COMMUNITY DEVELOPMENT DEPARTMENT
 80 Columbia Avenue ♦ Marysville, WA 98270
 (360) 363-8100 ♦ (360) 651-5099 FAX

Re: Brodie Subdivision – Pre-Application - PreA22-026

This letter is intended to summarize the Planning Divisions comments regarding the above referenced proposal. These comments are preliminary in nature and are based on the applicable development standards outlined in the Marysville Municipal Code (MMC) as of the date of this letter. Preliminary comments do not vest an applicant to the existing provisions of the MMC.

STANDARD PLAN 3-201-008

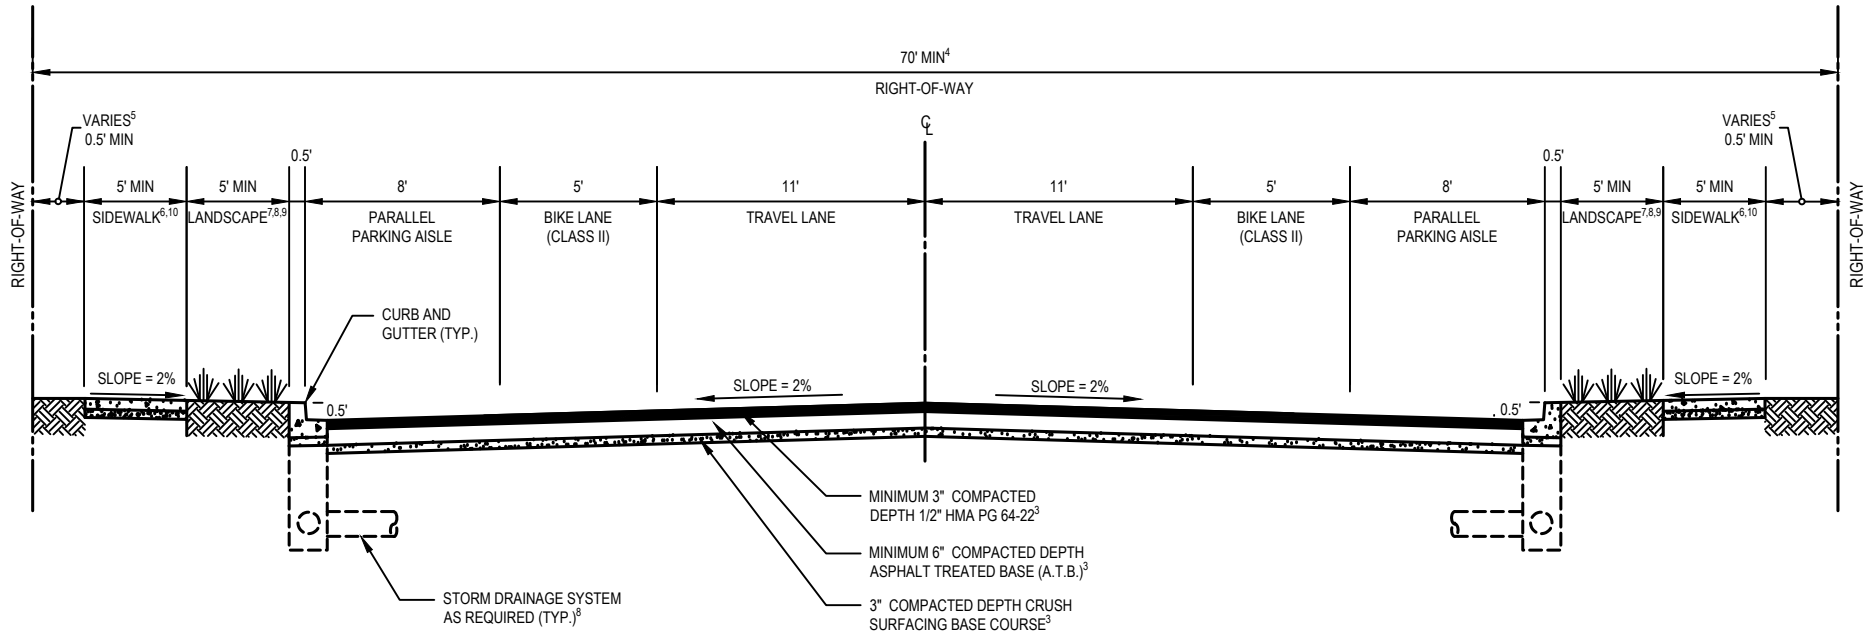
- 3) Per Comprehensive Plan, the collector arterial of 87th Ave NE shall be extended between 60th ST NE and 64th ST NE (SR 528) through the subject development parcels.

- ii. EDDS Standard Plan 3-201-004
 - c. 87th Ave NE Roadway Alignment:
 - i. Evaluation shall be performed to determine if 87th Ave NE can be aligned with existing traffic signal at intersection of 87th Ave NE & 64th St NE (SR 528).
